# "RADIO AND VICTROLA" SERVICE TIPS

VOLUME XVI, ISSUE I

MARCH 12, 1965

RS-195, A & B Tape Recorder Amplifier Chassis  
Switch Change

Schematic Diagram RS-195

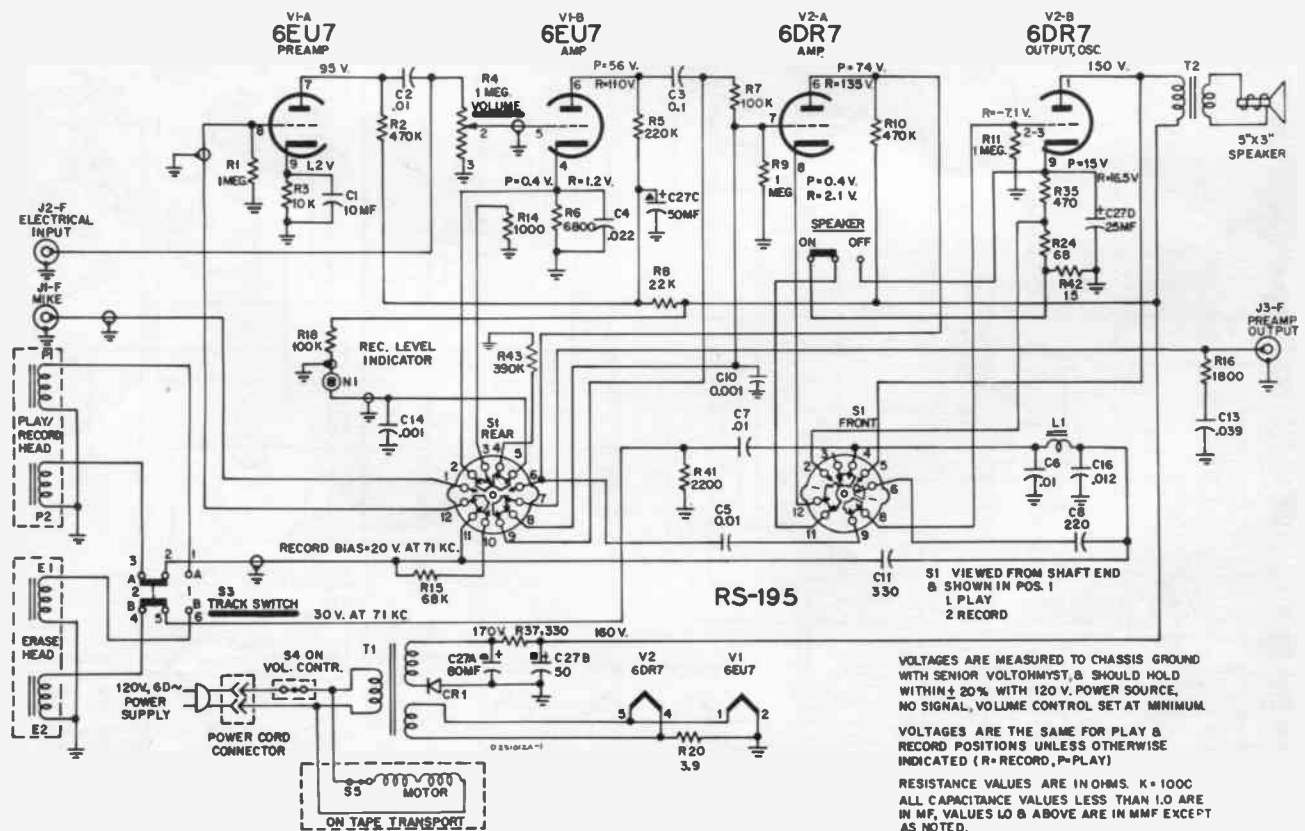
In the course of production some changes were made in the RS-195, RS-195A and RS-195B chassis. These changes consisted of a new switch wafer in S1, the "Play/Record" switch, and changes in the wiring of the switch.

In addition to the above, in the RS-195 chassis a resistor (R-43, 390,000 ohm) has been added from terminal 4 of S1 rear to ground. This resistor causes the "Recording Level" indicator to burn steadily, when the "Play/Record" switch is in the "Play" position, thus serving as a pilot light on playback. Its original function as a recording level indicator on "Record" is not changed.

The revised schematic diagrams of the three chassis are reproduced herein.

TCT-3 Tape Transport.

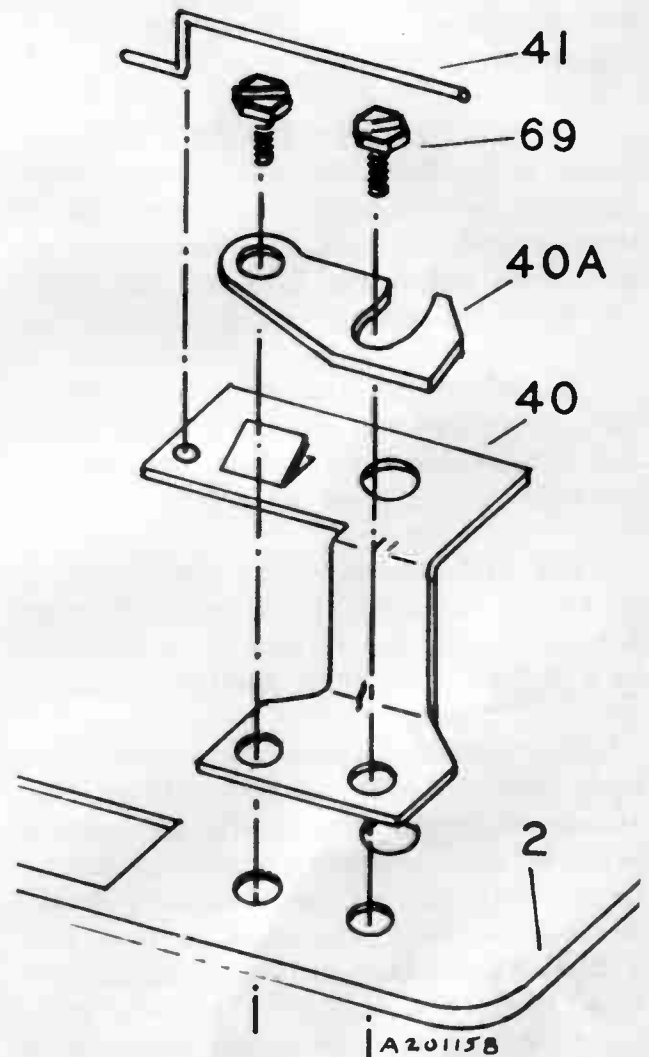
Mechanism fails to shut-off at end of play.  
Grooving of pressure roller.

One of the major causes of wearing and grooving of the pressure roller is non-tripping of the transport mechanism at the end of the tape. This condition will normally occur at the end of play, particularly when in the  $1\frac{7}{8}$  speed position, seldom at the end of rewind.

A correction for this non-tripping is to install a "Trip Force Adjustment Cam" (40A) (see illustration). The cam is installed between the screws mounting the control pivot bracket (40) to the motorboard, and the bracket, as shown in the illustration. Its purpose is to act as a stop to limit the clockwise travel of the control pivot assembly in the play position thus effectively reducing the force required to trip the mechanism. It is adjusted by moving the cam in or out, as permitted by the slot, till the point is obtained where the mechanism will trip easily at the end of the tape.

The cam is obtainable from Parts & Accessories. It is available by itself under stock no. 116375 and is also packaged, along with two longer mounting screws, with the pressure roller (stock no. 110276).
